CERTIFICATE OF REMEDIATION

Property: 7706 Lakewind St, Lot 7, Block 62, Glenbrook Valley Sec 11 Subdivision. The property includes a historic 2,700 square foot, one-story single-family residence situated on a 13,516 square foot interior lot.

Proposal: Alteration – Windows

SAMPLE COMPARISON – HISTORIC WINDOWS / PROPOSED WINDOWS

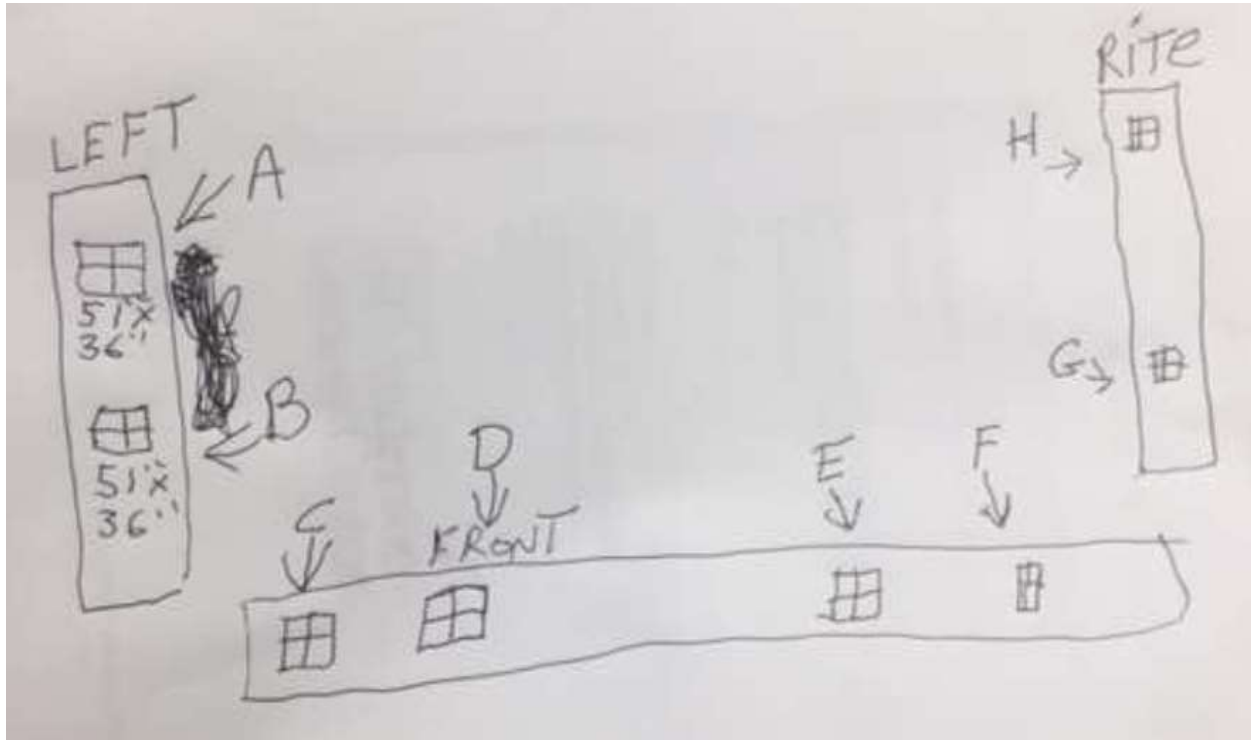
<i>The square grids within the new windows are not compatible with the removed diamond-paned casement windows.</i> | |

If the applicant installed diamond-paned casement windows with exterior grids and fixed (or visually compatible operating style) windows with exterior grids on the front elevation, and windows with exterior grids on the side elevations, staff believes the proposal would satisfy criteria 1, 3, 4, 5, 6, and 10. The proposal would not satisfy criterion 9, and staff would recommend a Certificate of Remediation.

HAHC Action: Denied. Certificate of Remediation issued for the installation of new windows which have already been installed. The windows on the east and west elevations may remain; the applicant will work with staff to replace the front windows with windows compatible with original.
